Babonié Plaque - Recording explanation of
discrepancies pointed out in the plan on white
paper submitted by Surg Major Bannerman

*Submitting further information
with reference to G.O. No. 1149
dated 8. 11. 97 regarding certain
discrepancies pointed out in the
plan submitted by Surg. Maj.
Bannerman for 10 beds.*

Forwarding letter from Surgeon
Major Bannerman furnishing
explanation with regard to cer-
tain discrepancies pointed out
in the plan on white paper
of the half section Hospital.

HALF-SECTION HOSPITAL 10 BEDS.

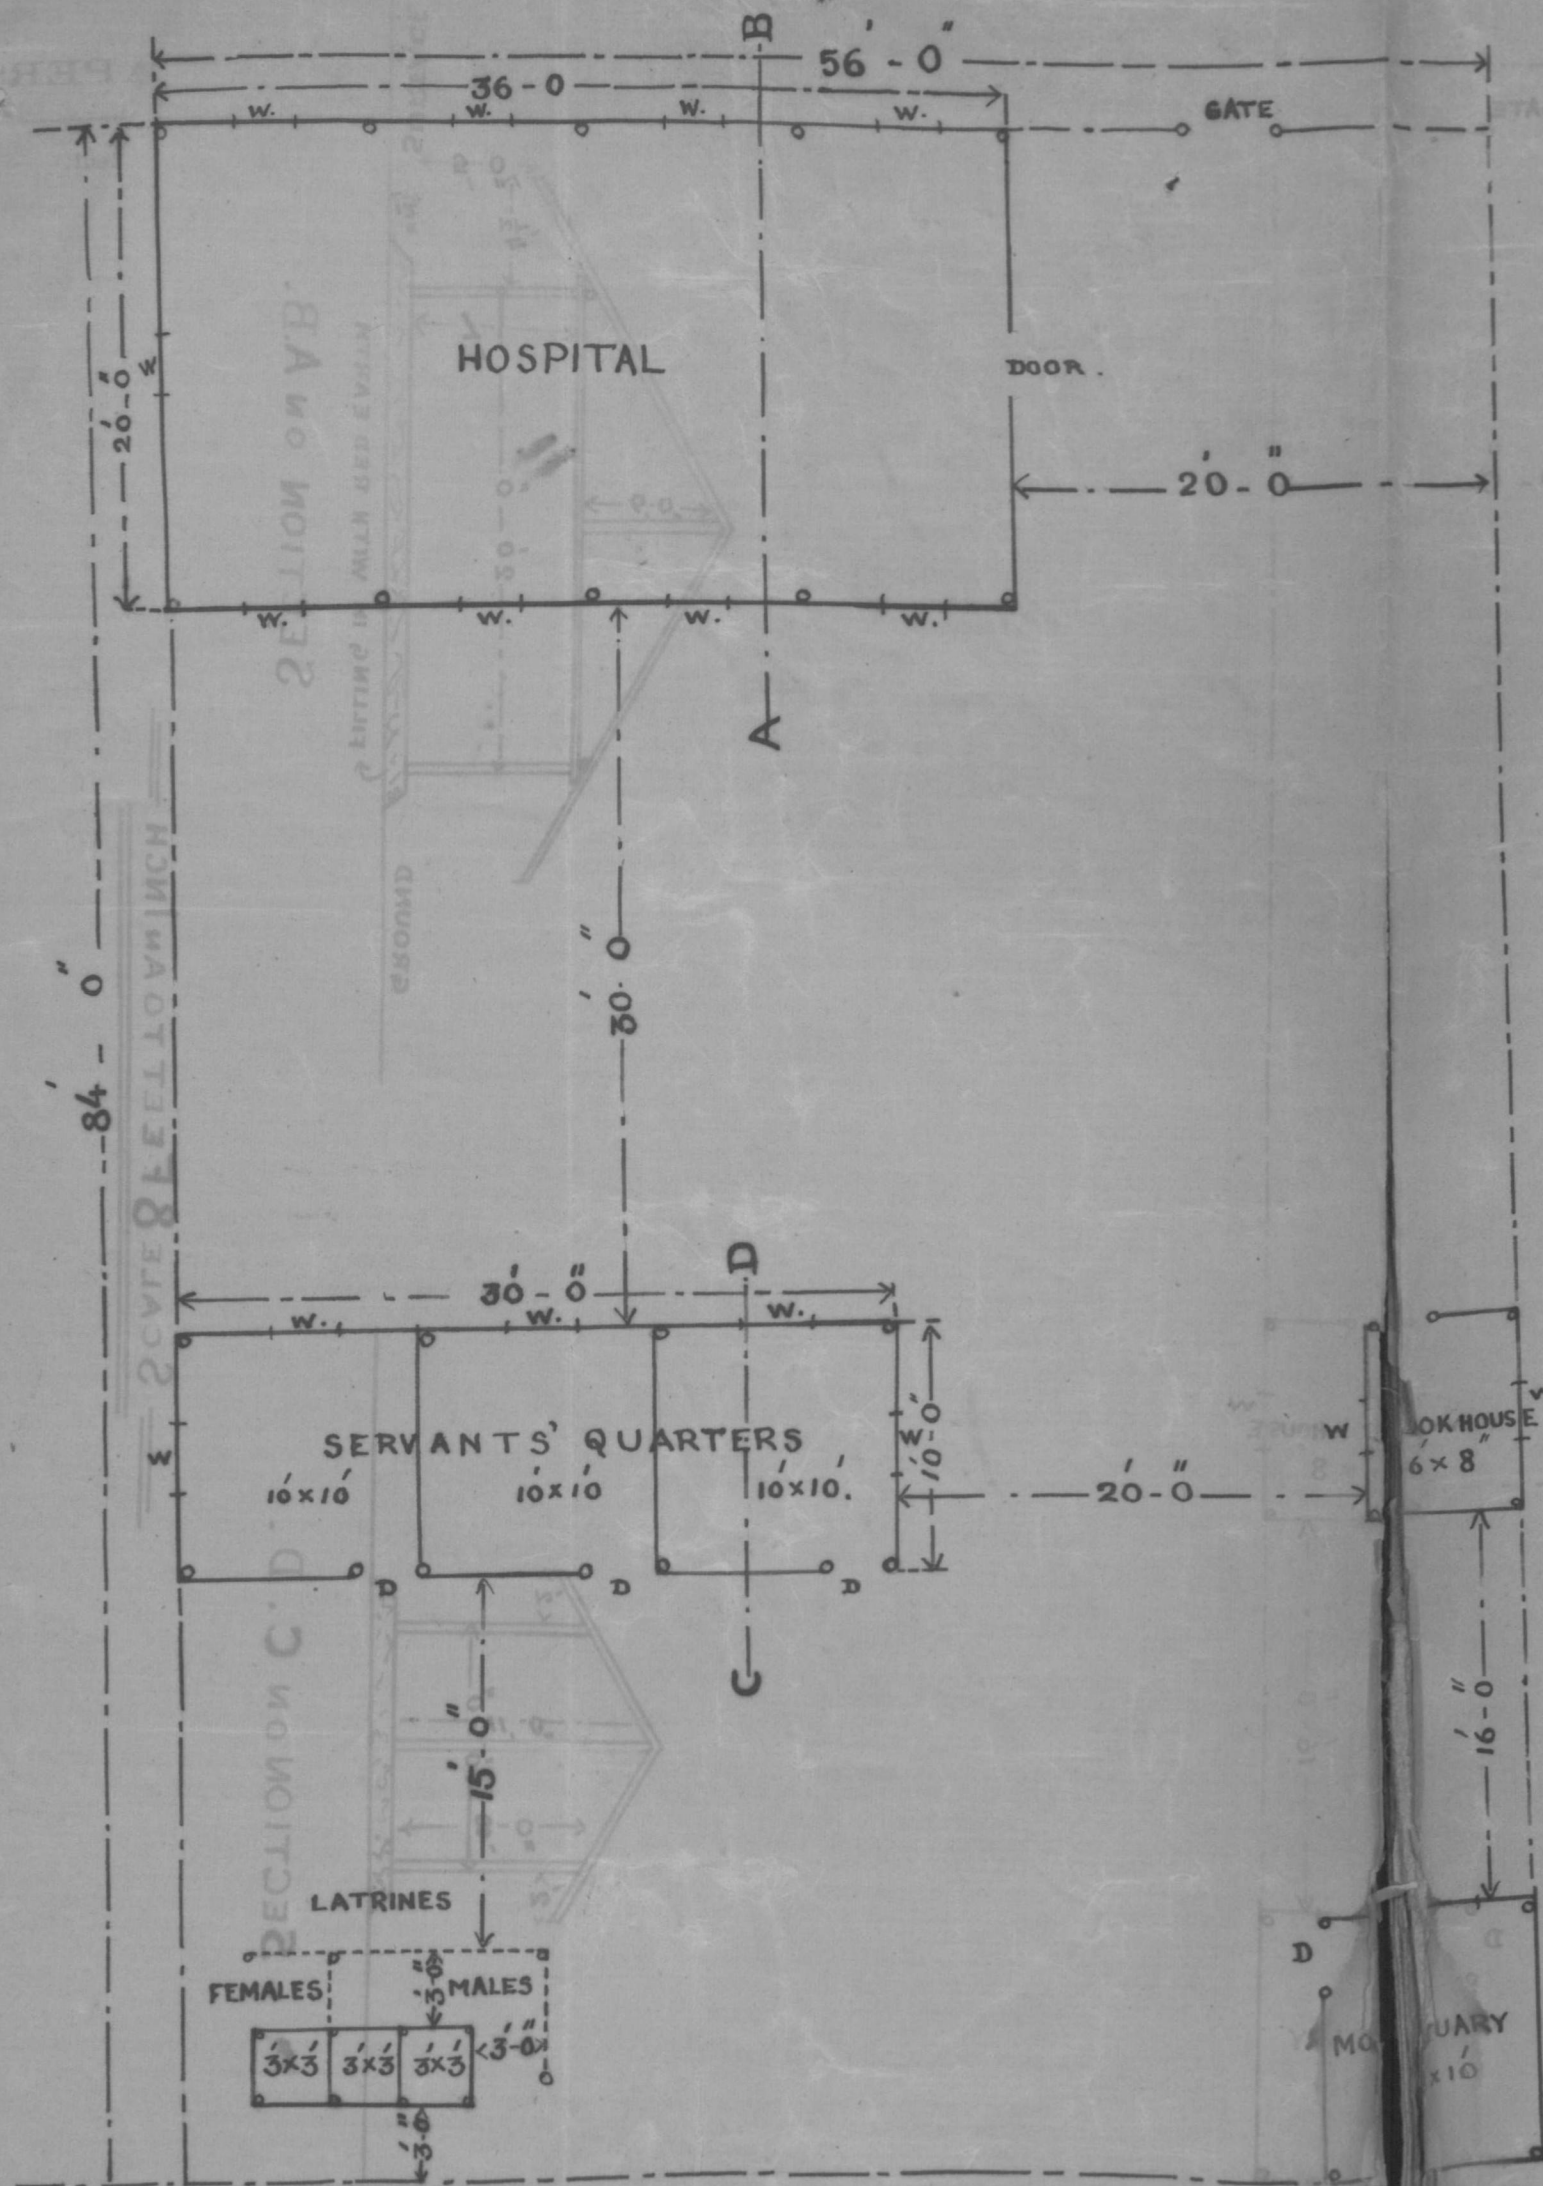
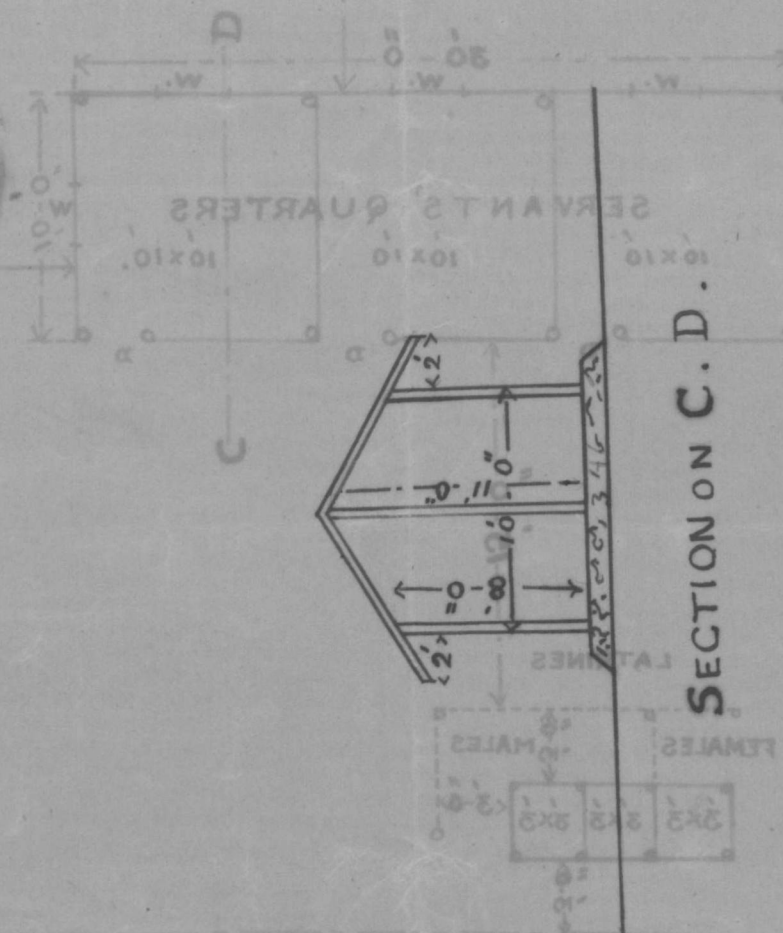
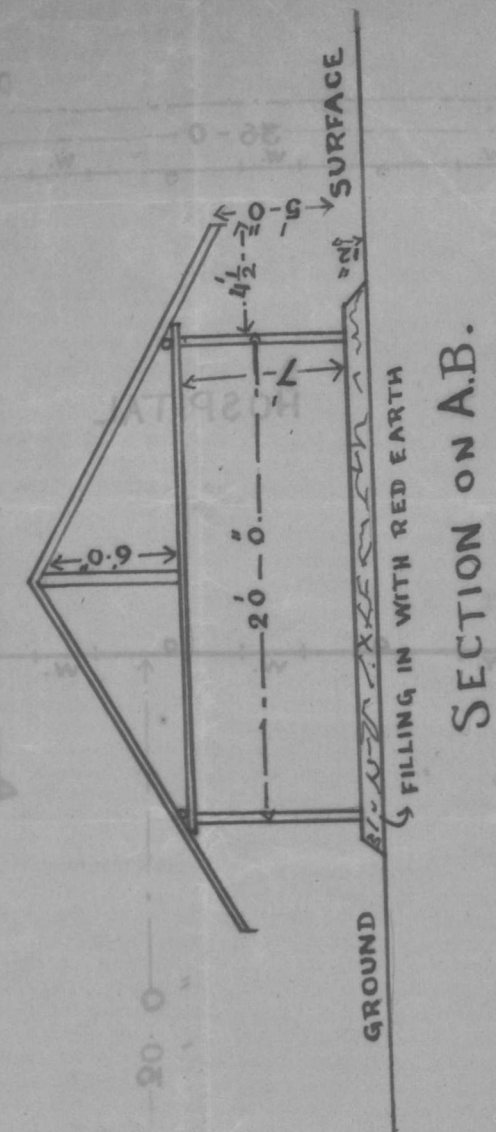
Surgeon Major Bannerman is apparently against the adoption of the plan on white paper.

But. Rather, he is in favour of giving more space for the beds, or fewer beds for the area shown. But with this correction the plan ~~is~~ ^{are} ~~is~~ ^{are} useful limits as to the ^{general} disposition of the

hospital, servants quarters,
latrines &c. The blue
paper plan however
does this, & the accommod:
shown on that may be
modified in each case to
suit requirements: & perhaps
it's not worth while doubling
local beds with two
plans

The plan on white paper
submitted by Surg. Major
Bannerman purports to
provide for 10 beds, but the
area covered by the hospital
is apparently only 720 sq. feet, so that
each patient ~~can~~ will have only
72 sq. feet, whereas it is
stated in para 8 of his report
that a superficial area of
144 sq. feet for each patient
is none too large. Necess:
quarters and other particulars

are also not shown on the
plan. ~~He will therefore be~~
returning to Dr. Bannerman
for a fuller explanation
in view of the
necessary details being filled
in & fuller information furnished
with the plan. (From order on 27. 11. 97)

the honour to state that Surgeon Major Bannerman explains that the plan on white paper has been used in confined localities, but that he adheres to his opinion that 144 ^{sq} feet should be required.

2. The plan on white paper of the half-section hospital, shows only 72 square feet for each patient, as it was intended for use in crowded localities, where more space could not be obtained. As a matter of fact only one such hospital was erected in Bombay, and I should certainly not recommend a smaller space than 144 square feet for each patient.

3. For similar reasons nurses' quarters are not shown, but if such a small hospital were to be erected quarters similar to those shown on the large plan would be provided if space was available.
